**Response to Feedback by NSW Department of Planning, Industry & Environment
Regarding EIS Acoustic Assessment Report**

We are writing to address the feedback provided by the NSW Department of Planning, Industry & Environment (NSW DPI&E) in their letter titled "*Macarthur Medical Research Centre SSD-17491477, Review of environmental impact statement*" (dated 4 November 2021), regarding the submitted acoustic report titled "*Lang Walker AO Medical Research Centre – Macarthur, Environmental Impact Statement – Acoustic Assessment*", dated 29 October 2021 (referred herein as the EIS Acoustic Assessment Report).

Lang Walker AO Medical Research Building - Macarthur

Environmental Impact Statement – Acoustic Assessment

Figure 3 Site layout and noise logger locations

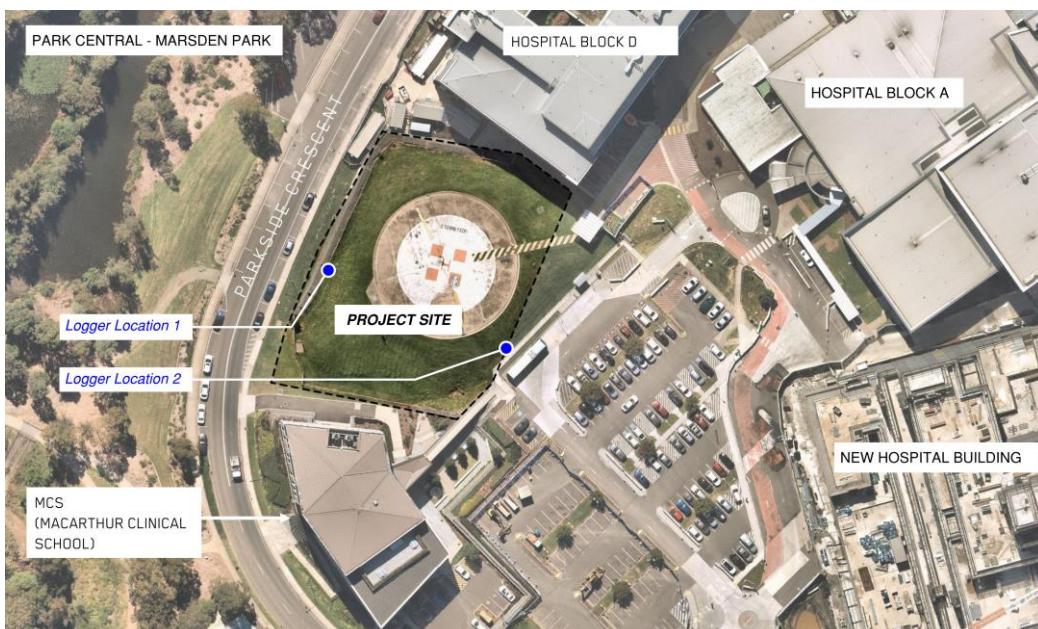
NSW DPI&E: Noise monitoring cannot rely solely on past data from the Stage 2 Campbelltown Hospital redevelopment and the Acoustic Report must be updated to include more recent testing both within the hospital campus and at the closest residential receivers to the west and south of the proposal site.

Finally, please note that an unattended noise survey was conducted on site. The aim of this survey, however, was to quantify façade incident noise levels rather than to obtain a measurement of the ambient noise level. Since the hospital was operational during the COVID-19 lockdown periods, and local roads surrounding the MMRC are dominated by hospital traffic, a survey to quantify façade L_{Aeq} noise levels was considered worthwhile. The survey was conducted just before the full implementation of lockdown restrictions.
